MANDATORY SERVICE BULLETIN

IS-28B2/EO-7

Product : IS-28B2 glider

Object : Additional indications concerning the
wing locking.

Fig. 6.2.1 Main junction tightening

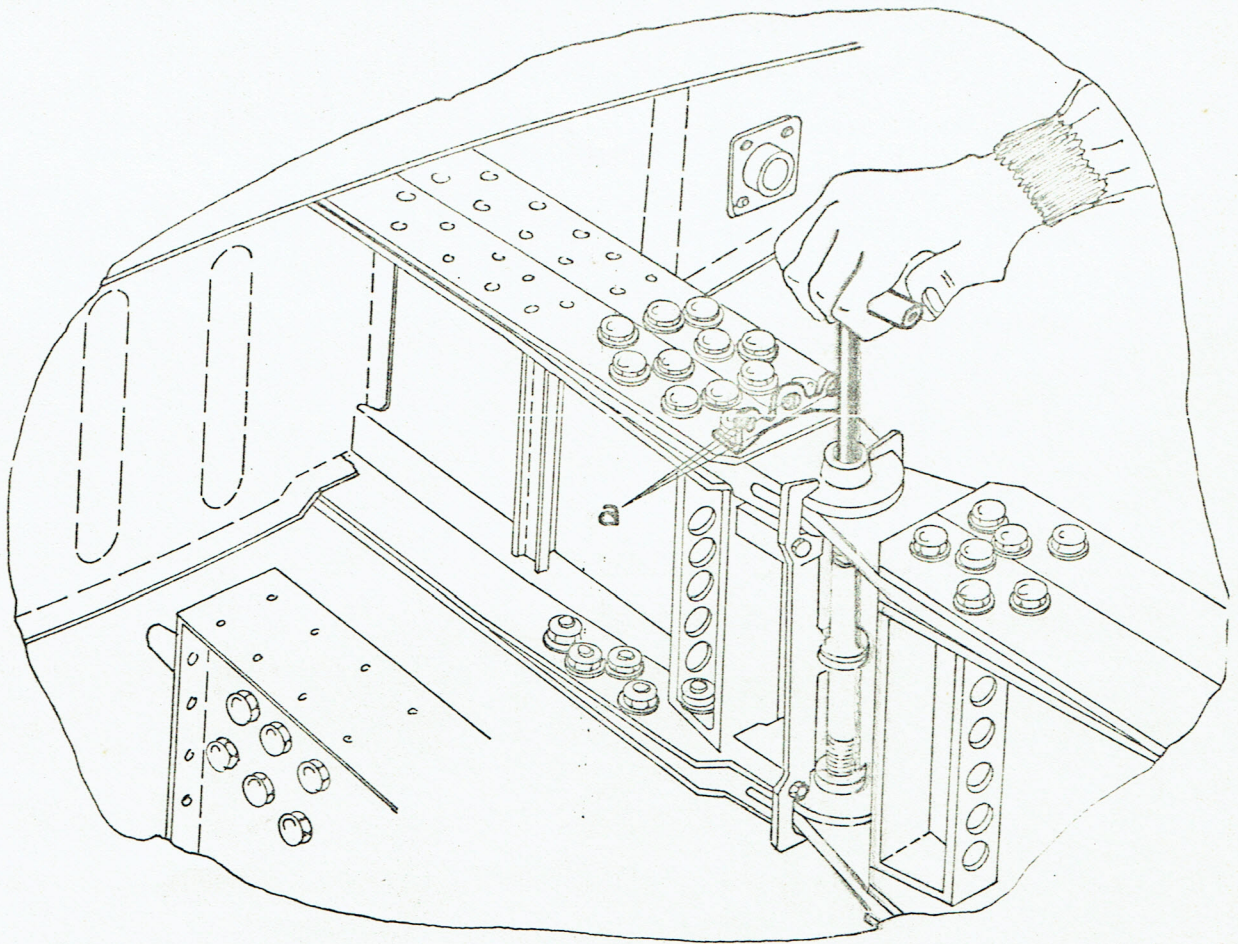
The junction wrench shall be actuated by hand only (without using extensions).

During the whole tightening operation two persons shall raise and lower the wing extremities simultaneously to facilitate the cones lead in.

Match the wrench into one of the three locking holes indicated by "a" by removing, twisting and inserting it, until the correct position is found (sometimes a slight tightening is also required).
